Agenda Item	6.2
Report No	PLS 055/19

HIGHLAND COUNCIL

Report Title: 18/05427/S36: ILI (Highlands PSH) Ltd
Land 630m east of Park Cottage, Dores

Description: To construct and operate a pumped storage hydro scheme approximately 14km SW of Inverness.

TITLE
 FIGURE 2.21
 C1064 REALIGNMENT
 INDICATIVE ARRANGEMENT

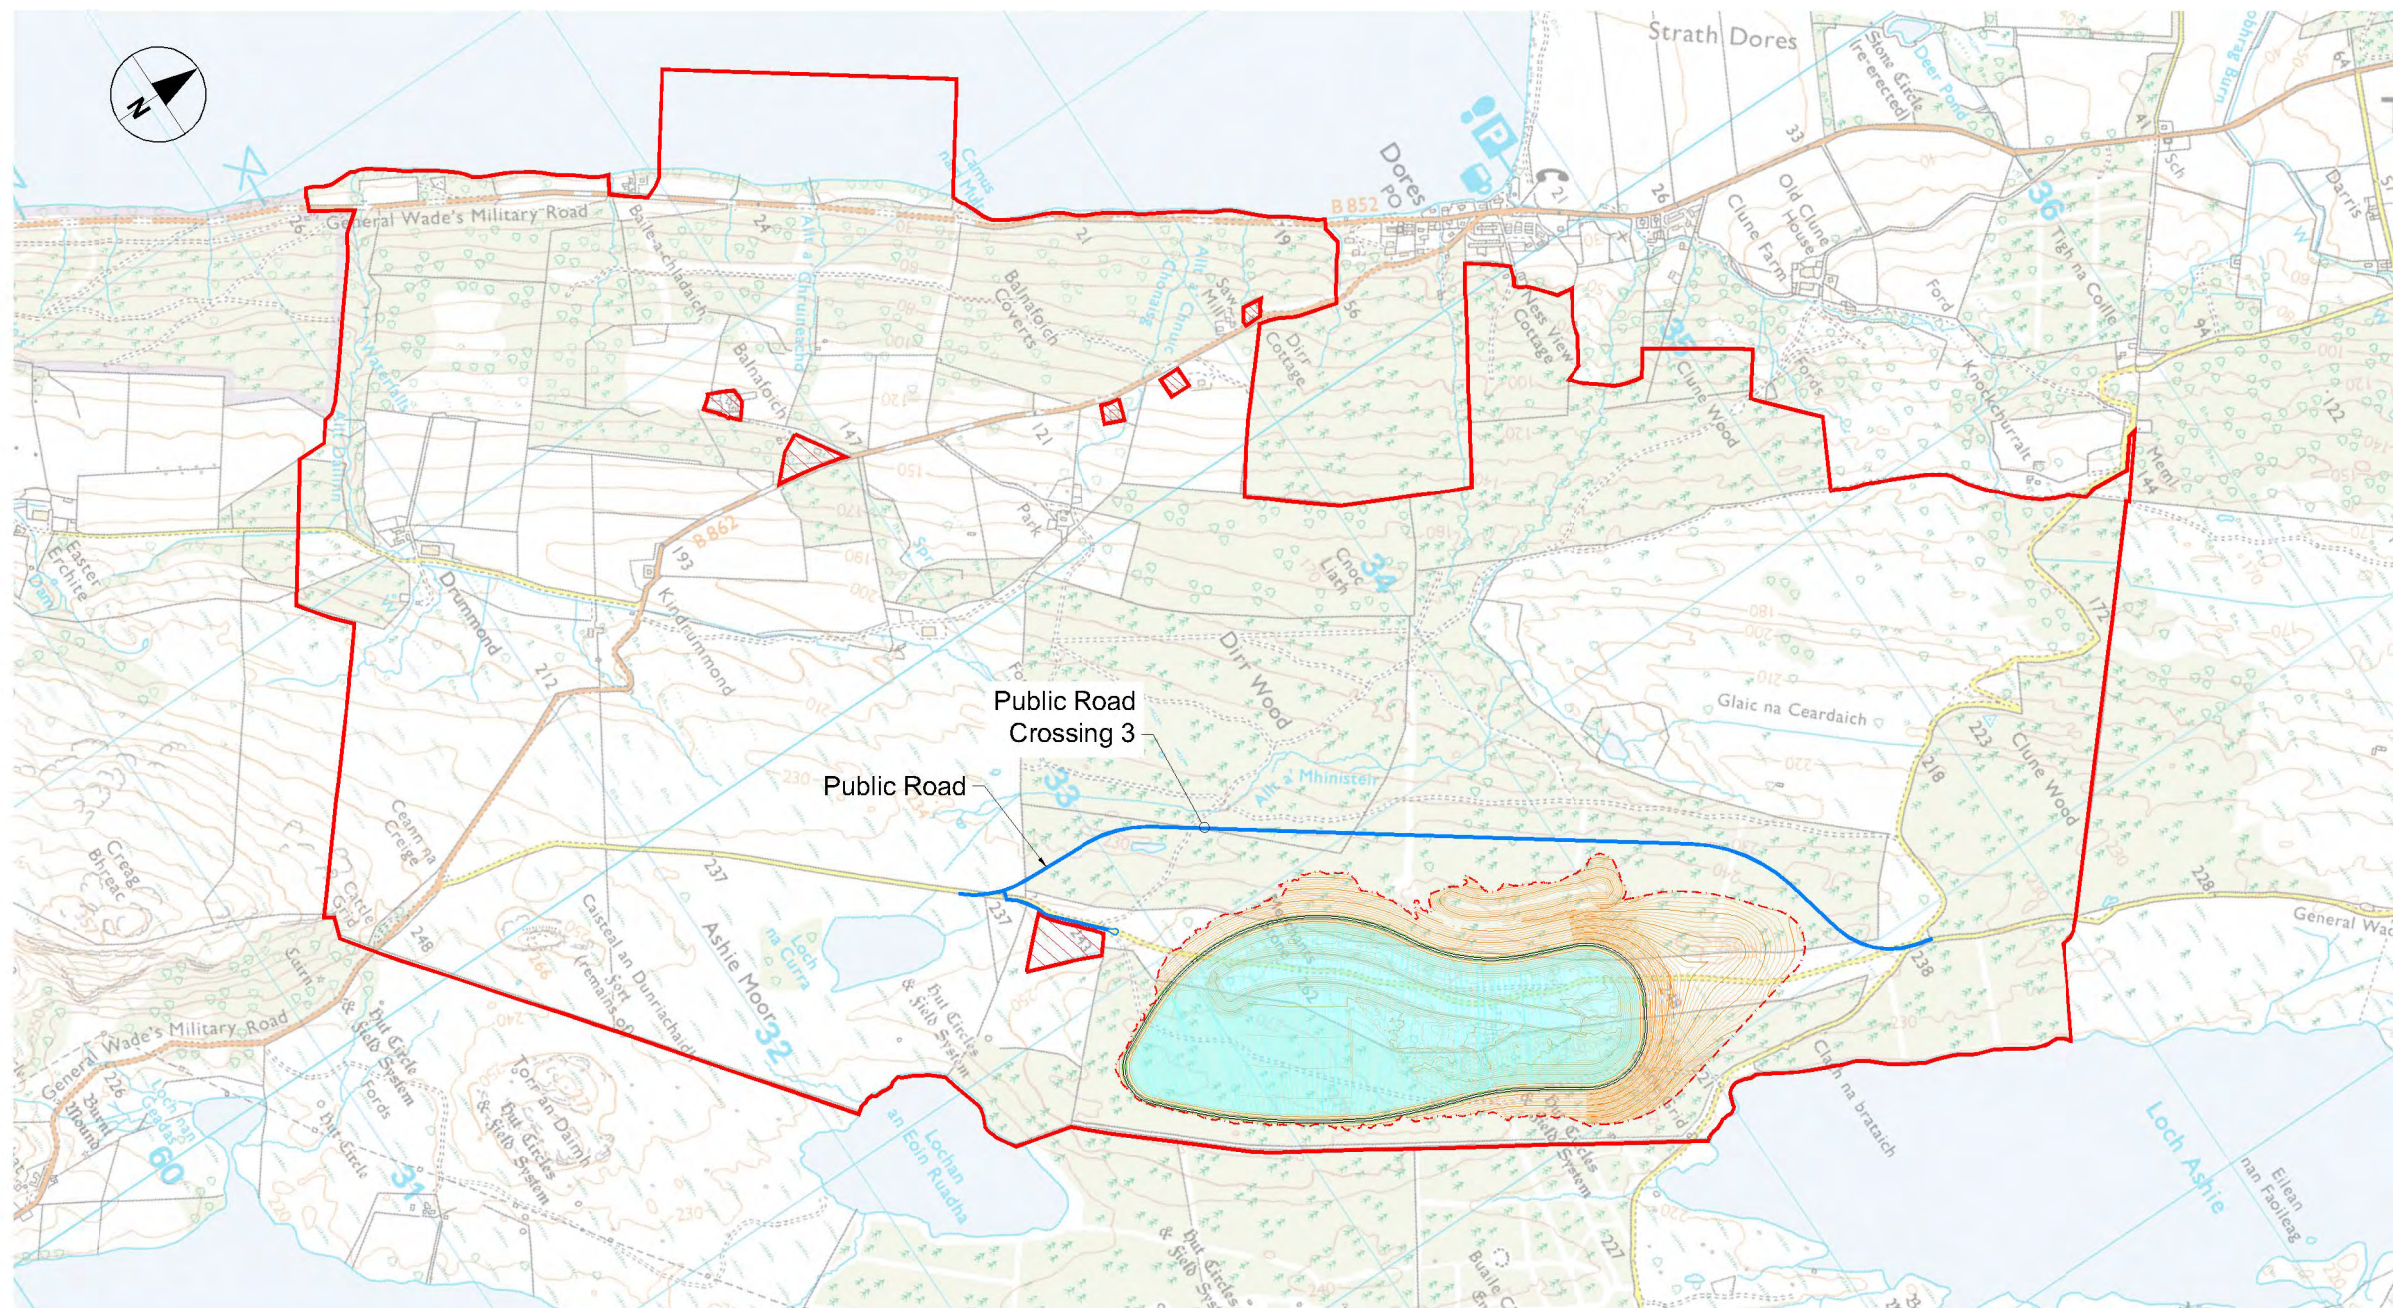
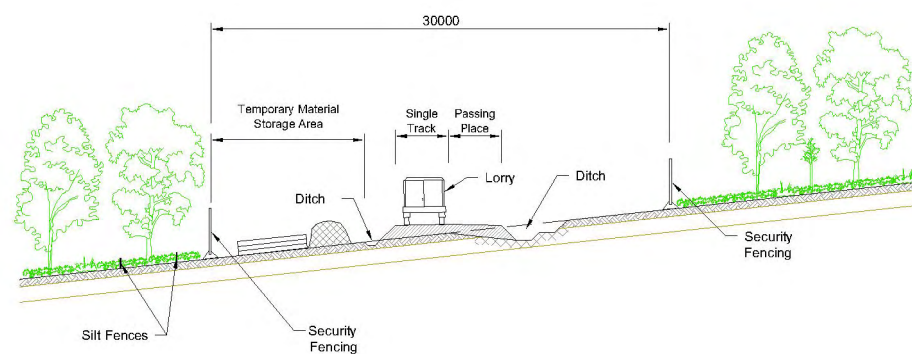
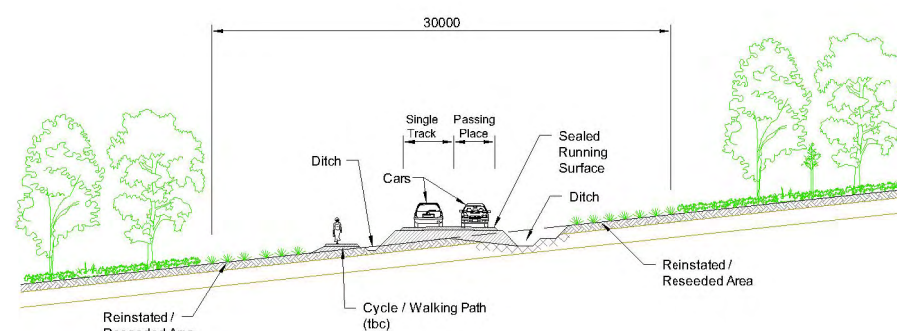
- 8.26 The Transport Planning Team do not have any objections in principle to the road realignment and building it to standard is welcomed. Current drawings imply a straight road running alongside the head pond and embankment in a linear fashion. The Council will require further detail on the finalised design, but it should be noted that the current alignment is not considered acceptable for visual amenity reasons and it is expected that the final road design include gentle bends, inclines and dips to avoid such engineered straight lines and therefore a better fit with the landscape. Should an appropriate design standard be submitted (which would also require Road Construction Consent) the realignment is not considered to raise any significant issue.
